1955 Corvette: Service Bulletin: Hard Shifting

CHEVROLET—CENTRAL OFFICE DIVISION OF GENERAL MOTORS CORPORATION DETROIT 2, MICHIGAN	
TECHNICAL SERVICE BULLETIN Service and Mechanical Department	
SUBJECT: HARD SHIFTING - 1955 MODEL PASSENGER CAR 3-SPEED TRANSMISSION	BULLETIN No. DR #236 SECTION VII
TO: ALL CHEVROLET DEALERS	January 9, 1956
<p>In cases where hard shifting on 1955 Passenger Models with 3-Speed Transmission is experienced in high frequency shifting operations due to malfunction and/or wear of gearshift controls and butting of transmission gears, the condition may be reduced by installation of a Transmission Control Conversion Kit and three new type transmission gears.</p> <p>The new transmission gears which have more tooth chamfer entered production about July 5, 1955.</p> <p>The revised transmission controls entered production beginning with 1956 Model and the Control Conversion Kit has modified parts for use on 1955 Models.</p>

FIGURE I

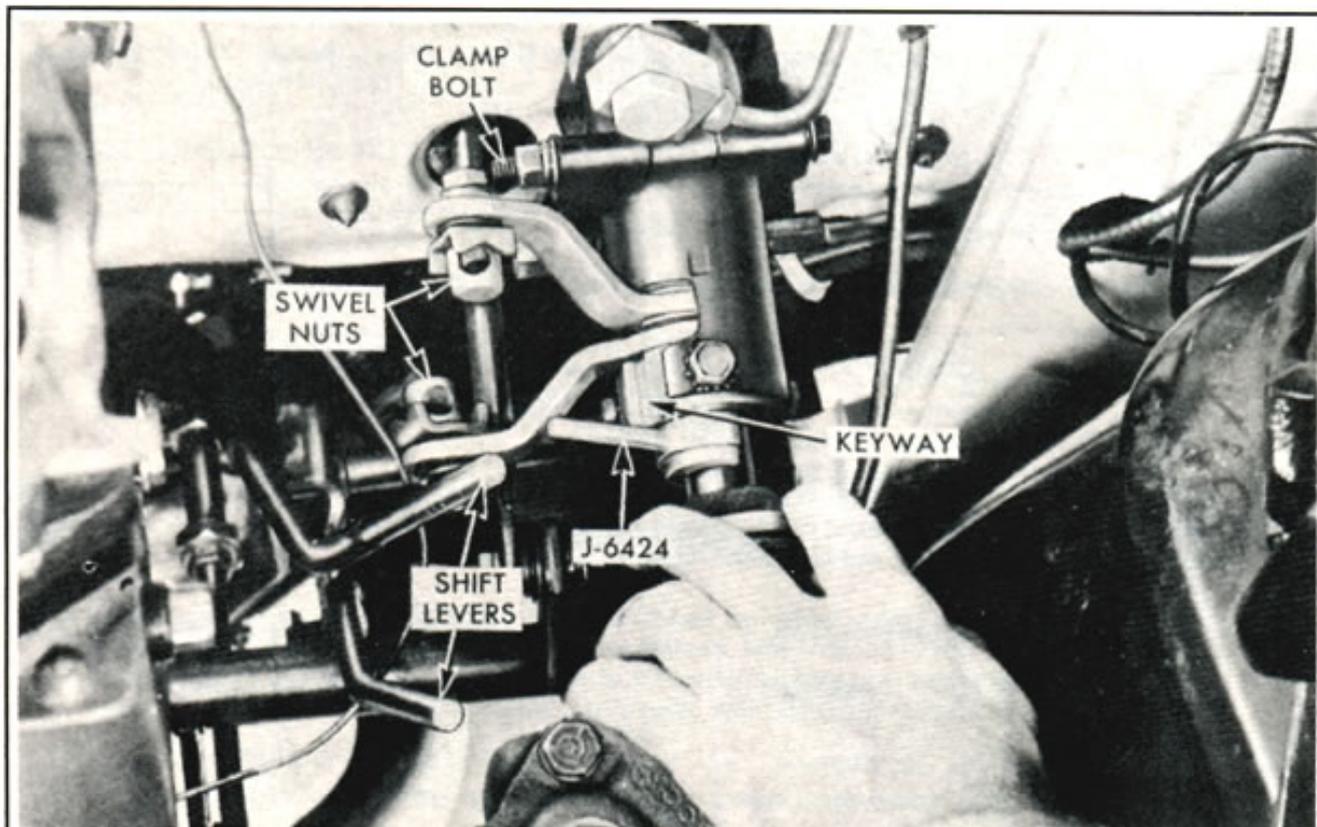
13. Insert gearshift rod ends in swivels - transmission must be in neutral detent in both ranges. Do not tighten.
14. Install alignment gauge J-6424 inserting side stamped "STD" between steering mainshaft and shifter tube in key area. This sets the required 1/16 eccentricity in proper relation to the key on shifter tube. See figure 1.

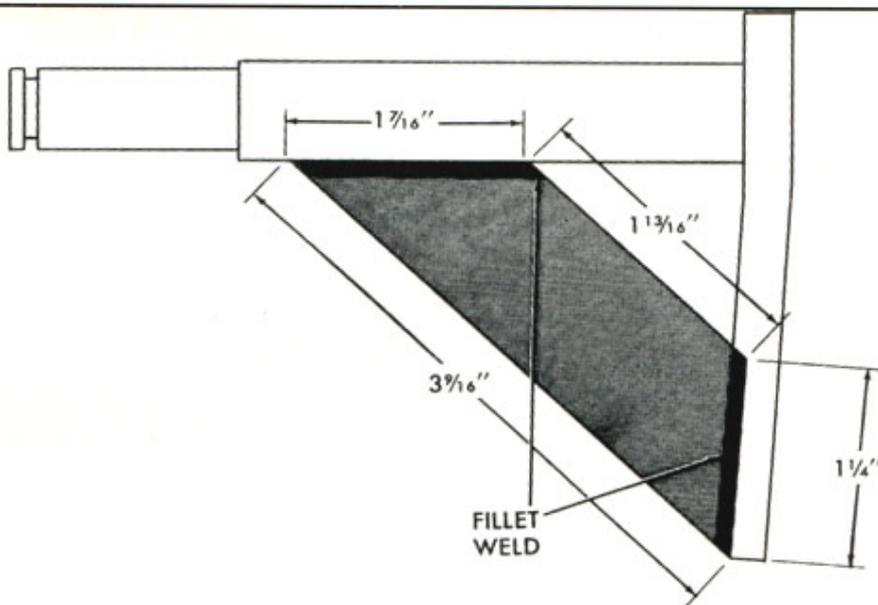
- c. Remove alignment gauge.
16. Make and insert special blade gauge, see figure 2, thru adjusting ring slot, lower levers and gate washer. Tighten swivels on gearshift rods while holding downward lightly on lower levers. Transmission must be in neutral detent at this time.

FIGURE 3

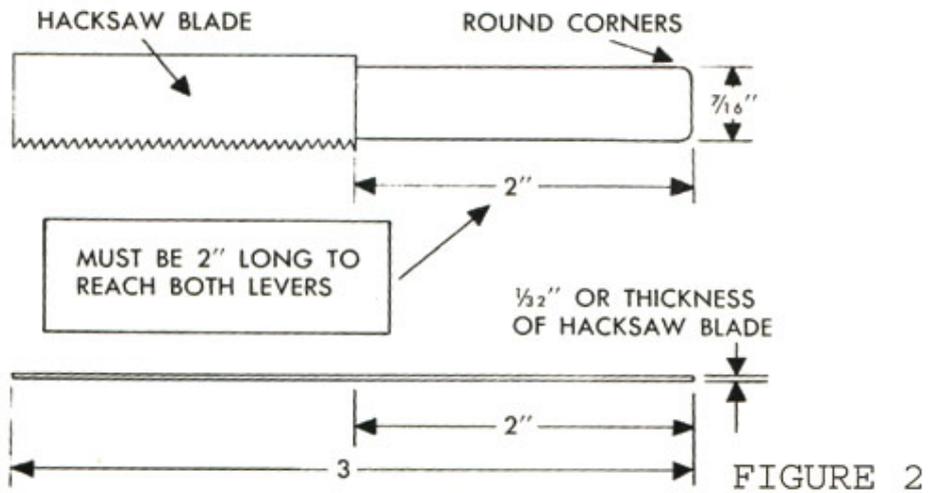
Further improvement of shifting can be made by reinforcement of transmission control rod idler lever support located on left frame rail under toe pan to reduce its deflection. See figure 3.
